# HISTORIC AND DESIGN REVIEW COMMISSION

December 05, 2018

**HDRC CASE NO:** 2018-195  
**ADDRESS:** 1603 BROADWAY  
**LEGAL DESCRIPTION:** NCB 964 BLK 18 LOT 6  
**ZONING:** IDZ RIO-2  
**CITY COUNCIL DIST.:** 1  
**APPLICANT:** Peter French/Graystreet Partners  
**OWNER:** Graystreet Partners  
**TYPE OF WORK:** Approval of a site plan for foundation and site work  
**APPLICATION RECEIVED:** November 16, 2018  
**60-DAY REVIEW:** January 15, 2019  
**REQUEST:**

# Site Plan

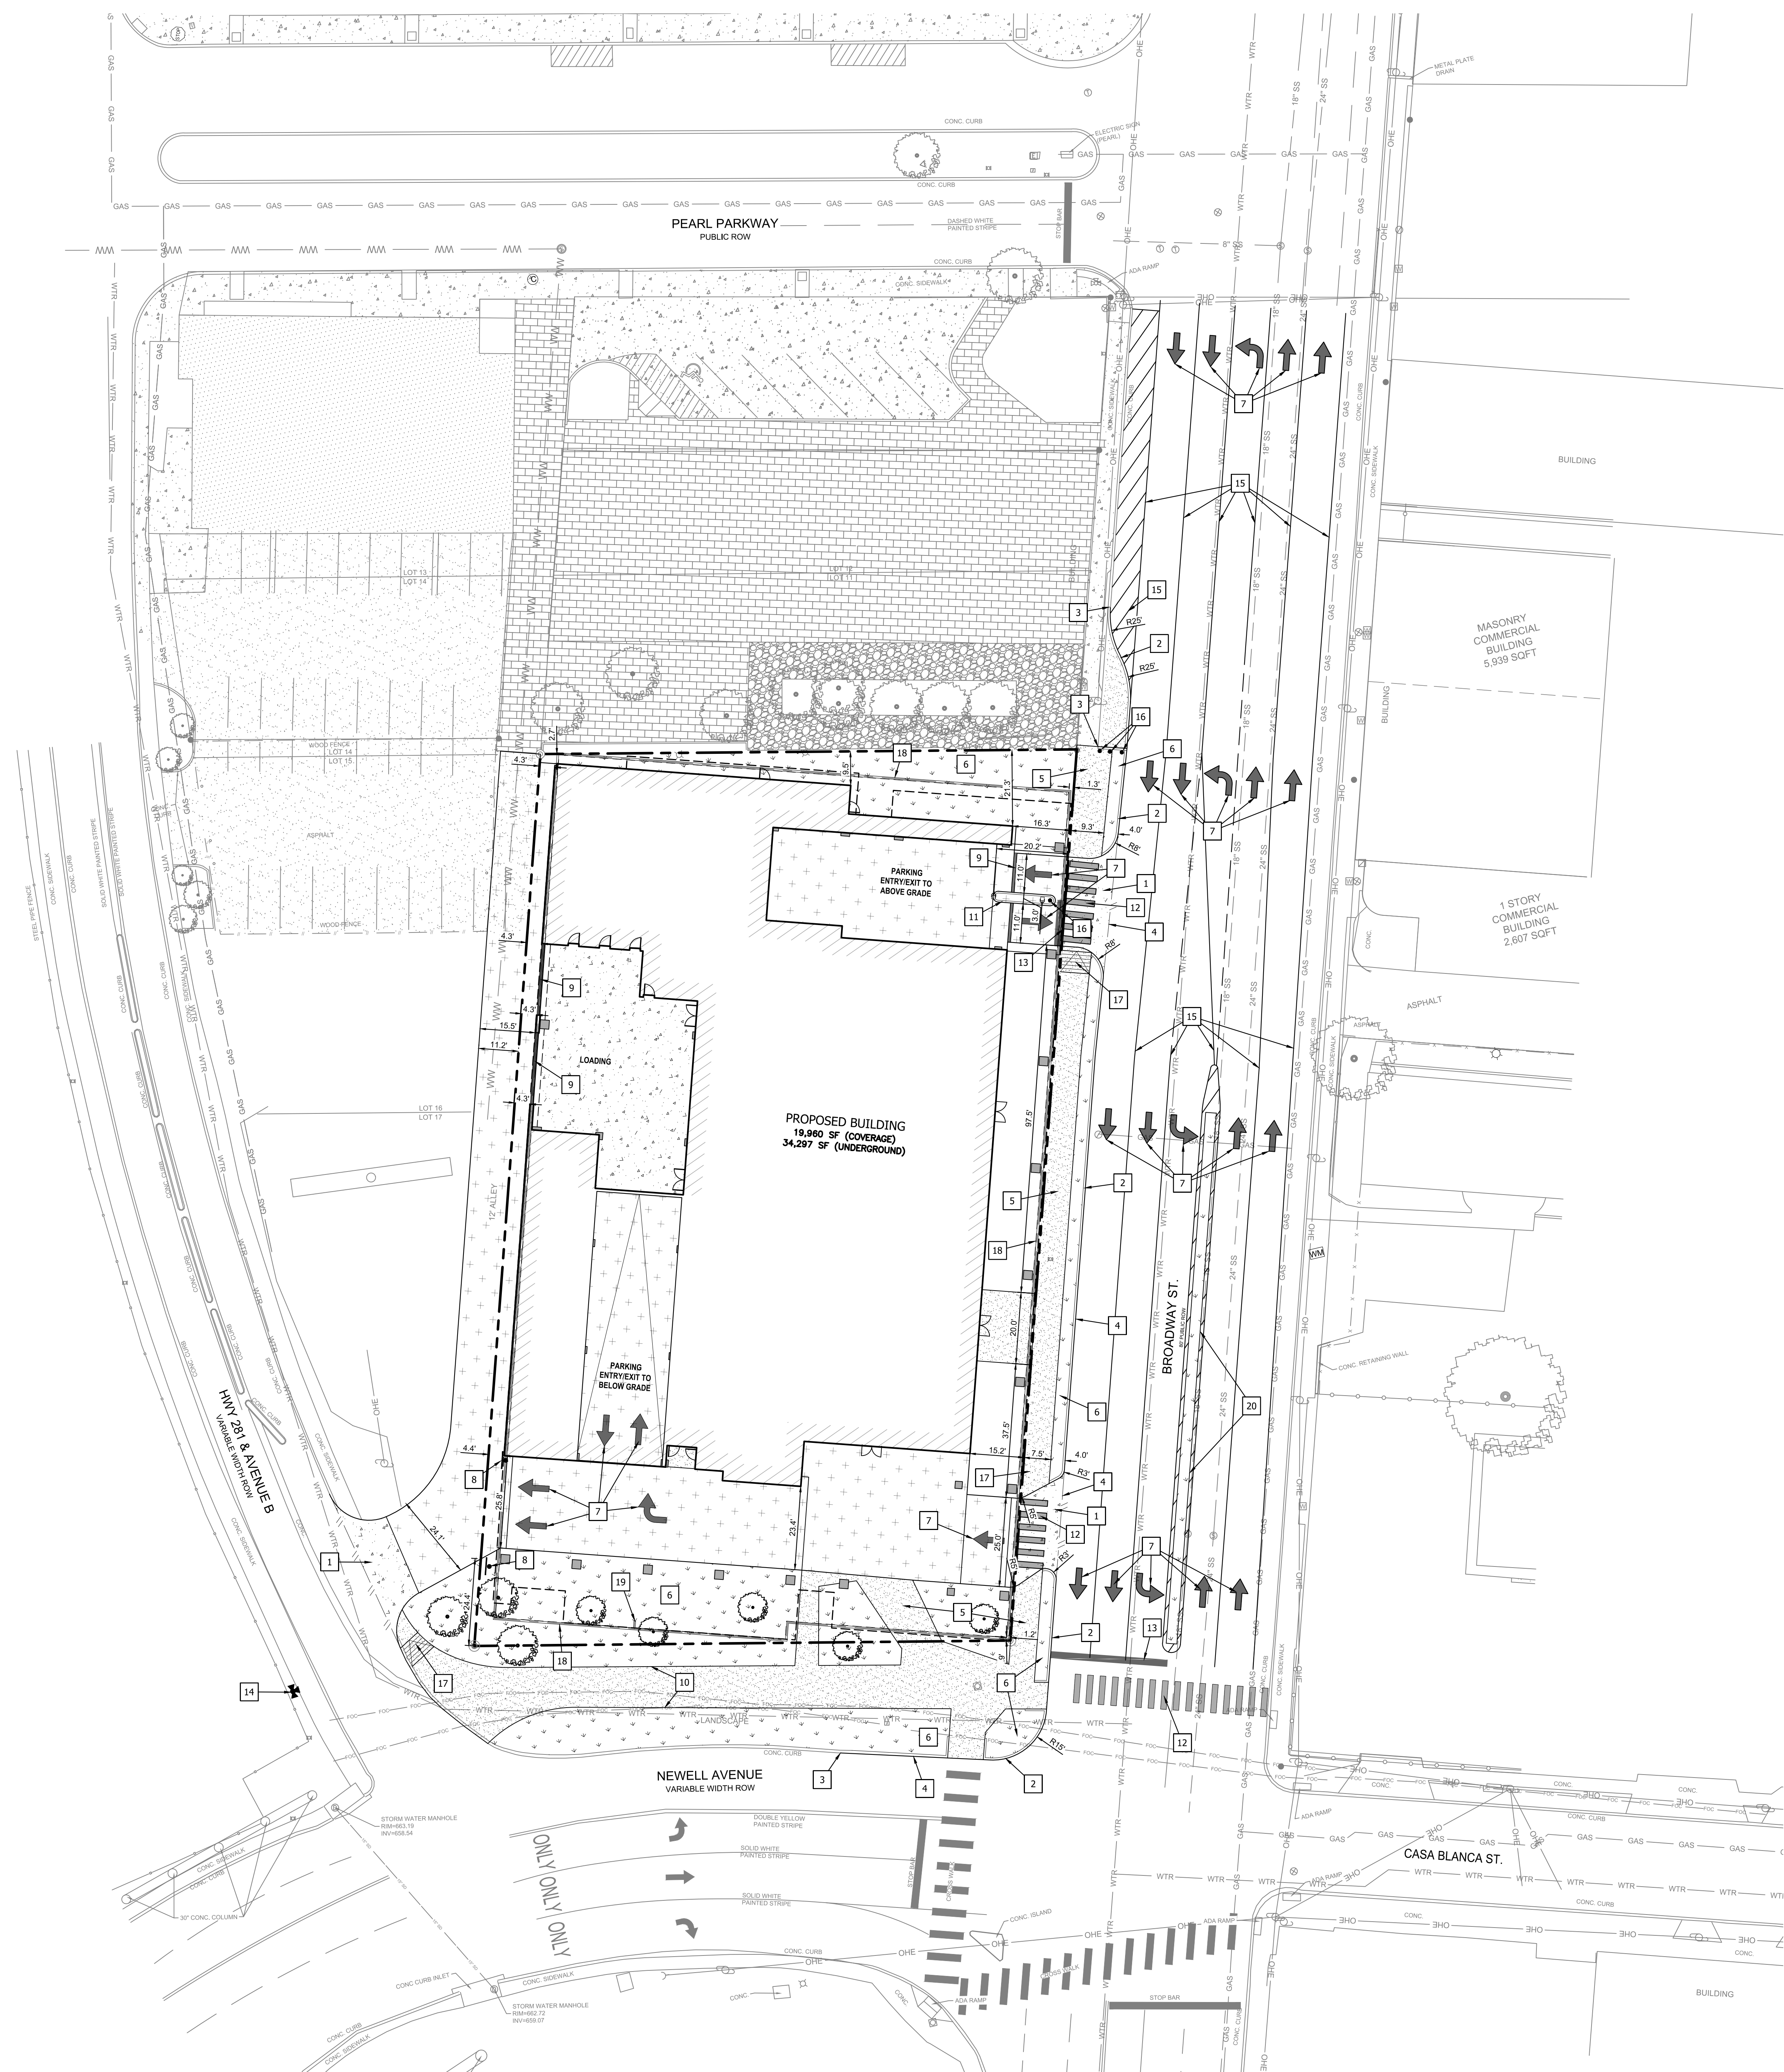
- i. That the applicant reduce the number of curb cuts on Broadway to only one and make attempts to eliminate curb cuts on Broadway altogether. The driveway closest to Newell should be eliminated.

- c. **CURB CUTS** – The RIO design objectives outlined in the UDC include the creation of a “positive pedestrian experience” at the street edge. Standards related to curb cuts and interference with pedestrian traffic are also provided. The applicant has proposed two curb cuts on Broadway and one curb cut in a rear alley that feeds onto Avenue B. The UDC requires projects to limit curb cuts to two (2) on parking areas or structures facing only one (1) street, and one (1) for each additional street face. The project has access to Broadway Street, Avenue B, and a rear alley. If Broadway was the only accessible street for the development, then the proposed two curb cuts would be allowable. As noted in finding b, a stipulation of conceptual approval was the reduction of curb cuts on Broadway to only one. Given that there are other opportunities for vehicular access to the site, staff finds that curb cuts on Broadway, where there is a focus on providing pedestrian-friendly environment, should be limited to only one. The intent of the upcoming bond project for Broadway is to promote pedestrian and bicycle activity along Broadway. Minimizing the number of driveways (conflict points) would be important to enhance the pedestrian/cycling environment. In addition to HDRC approval of the site plan, the applicant is responsible for coordinating with TCI regarding allowable curb cuts and obtaining all required permits. In an early review, TCI staff has further recommended that the curb cut closest to Newell be completely eliminated, and that the overall development focus on a singular entry from Avenue B.

Staff does not recommend approval based on findings b and c. A stipulation of conceptual approval was that one of the proposed curb cuts on Broadway be eliminated, which at this time, has not been met.

Staff recommends that the driveway closest to Newell should be eliminated. Additionally, changes in paving materials, limiting the flare of the driveway apron at the street, and inclusion of landscaped medians in double-lane driveways should be implemented at pedestrian conflict points to contribute to a safe and walkable environment.

With that said, our site plan, including sidewalks, driveway locations, and landscape planters has been reviewed and approved by TCI. TCI has approved our proposed design for the full width of the ROW in this section of Broadway as we own both sides of the street in this block. Our proposed design which includes pedestrian areas over 22' wide, far exceeds anything required by code and exceeds design requirements suggested by HDRC.
